CITY OF TORRINGTON

To: Planning & Zoning Commission
From: Martin J. Connor, AICP, City Planner
Date: February 13, 2020
RE: Special Exception 19-03 & Site Plan 1324, TDF Enterprises LLC, Notting Hill Gate and Wimbledon Gate North, Assessor's Map 219 Block 001 Lots 85 & 48, construct 4 buildings, 120 units total, fifty-five and over residential community

INFORMATIONAL TABLE

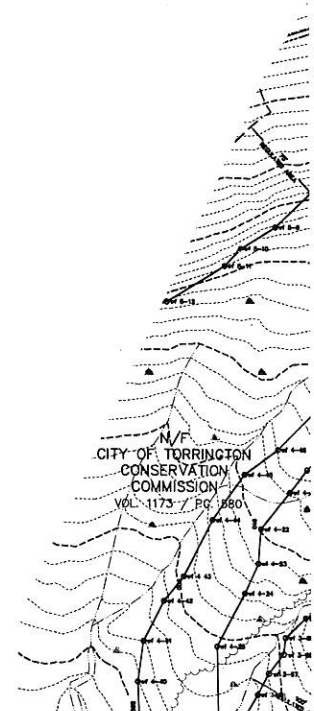
Can you please forward your revised parking chart the separates the required handicap spaces?

1. Did you include the total number of handicap spaces provided in the total number of parking spaces provided?
2. I don't see the calculation for the maximum impervious surface ratio. The maximum impervious surface ratio in the R-15 zone is 0.3. Did you include this calculation somewhere on the plans? I don't see it in the chart on sheet C-3.
3. I can't make out the site distance for the driveways on sheet C-3. Is it the distance figure listed in the Traffic Report?
4. There's no vicinity map in accordance with 8.4.3 0

Attached is a snapshot of the Revised Zoning and parking tables from Sheet C3.

- 1.) I will update the parking chart and separate the Handicap parking from the minimum required spaces.
- 2.) Total site Area = 39.35 Acres. Proposed Site Impervious = 5.09 Acres. Impervious Ratio = 12.9% (or .129) I will add to the Zoning Chart.
- 3.) Intersection Sight Distances for Lower East Drive are:
334' looking South, 510' looking North I will add that information to sheet C6.
